**Report to
Development Permit Panel**

To: Development Permit Panel
From: Brian J. Jackson, MCIP
Director of Development
Date: April 18, 2011
File: DP 11-564210
Re: **Application by Phileo Development Corp. for a Development Permit for
Phase II of the Proposed Quintet Development at 5900 Minoru Boulevard**

**Excerpt from the Minutes from
The Design Panel Meeting**

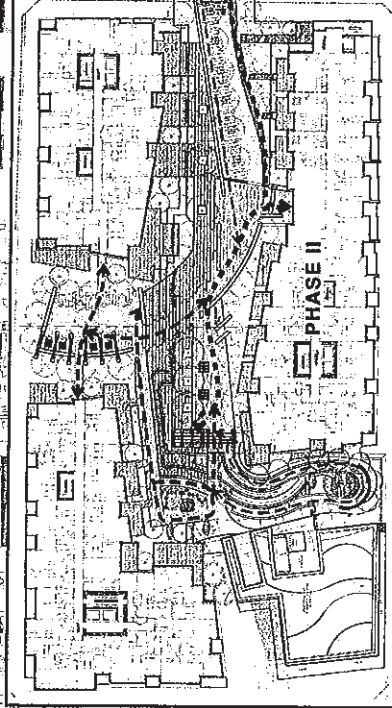
- appreciate the changes in texture, height and elevation of the podium; however, there is a lack of spaces for residents to pause and rest; an architectural structure such as a gazebo can be added as focal point in the courtyard; consider covered areas; define the path of journey from Phase 1 to Phase 2 and vice-versa;

- *Regarding the creation of passive/active open spaces to serve as stopping or rest areas, the definition of the outdoor rooms and their components is highlighted with the bubble diagram (see L04.a)*
